Product Change Notice (PCN)

PCN Number: PCN-0456985R-01

Product(s) Affected: PJ-040D / PJ-040DH / PJ-040CH Parts PJ-040D & DH have a center pin diameter of 1.3mm Part PJ-040CH has a center pin diameter of 1.0mm

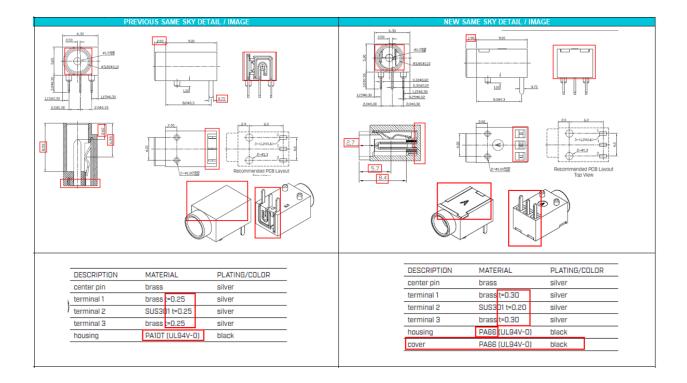
- 1) Internal differences regarding center pin offset from the front of the connector, distance to spring contact differs. Terminal widths and thickness differ. Housing has changed where a top cover has been added. The terminals coming out of the bottom differ. The back end is now enclosed.
- 2) Housing material differs. Terminal thickness differs.
